UNITED STATES PATENT AND TRADEMARK OFFICE

APPLICATION NO.	FILING DATE	FIRST NAMED INVENTOR	ATTORNEY DOCKET NO.	CONFIRMATION NO.
09/350,197	07/08/1999	DAVID A. MONROE	58959.10.23	7703

Office Action Summary

DETAILED ACTION

FIG. 5

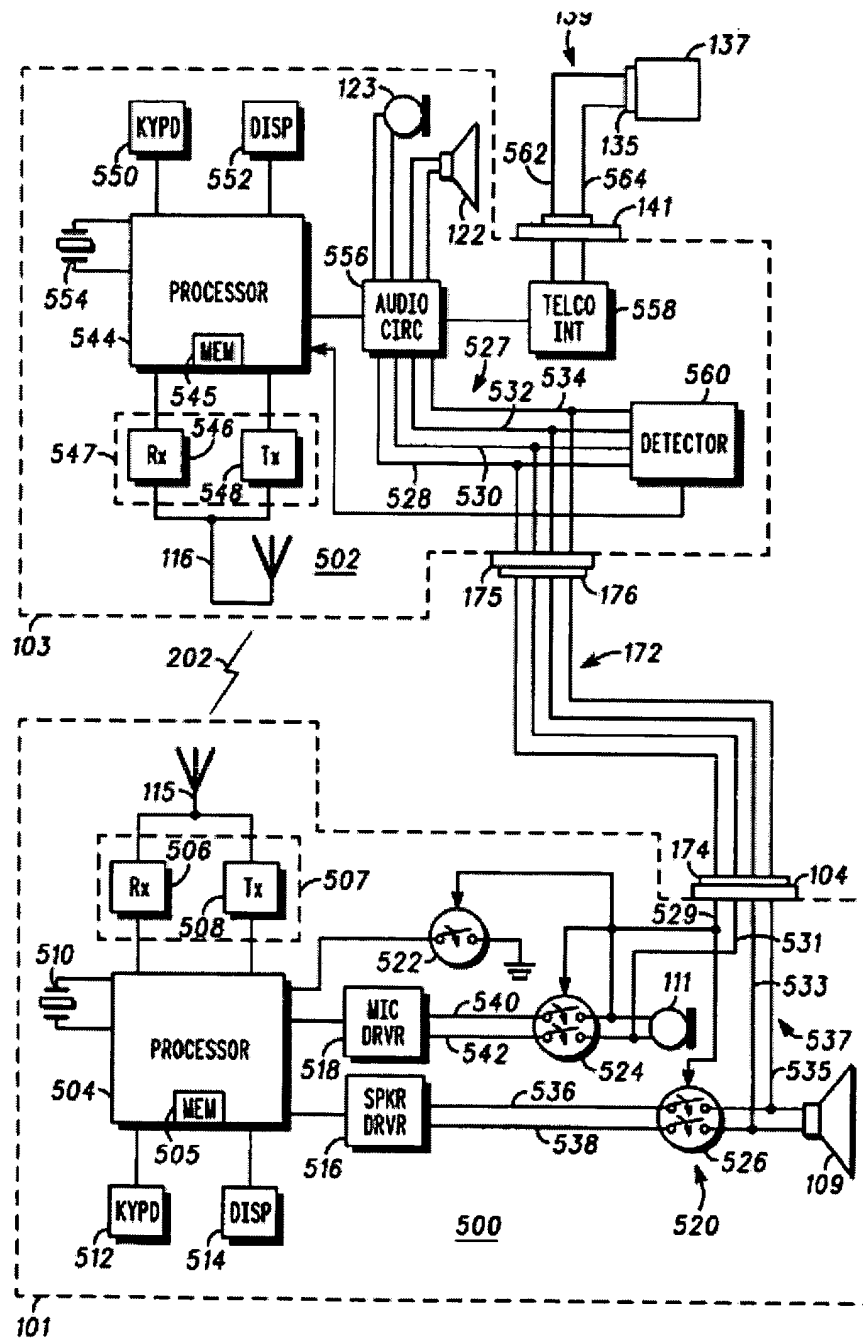
5. Claims 45, 46, 47, 48, 49, 56, and 58 are rejected under 35 U.S.C. §102(e) as being clearly anticipated by **Young, et al.**

Young, et al disclose an apparatus (figure 5) for selecting one of plurality of transmission systems (wired, wireless) having a connector (#172) for connecting the device (#101) to a first transmission interface (#556, 558, 141, 562, 564, 139, 135, 137). A second transmission system (#507, 115) provided as an integral component of the device (#101). A detector (#560) for detecting the presence of a first transmission system (wired) and a control system for selecting the first transmission system (wired) whenever it is present and selecting the second default system (wireless) whenever the first transmission (wired) is not present.
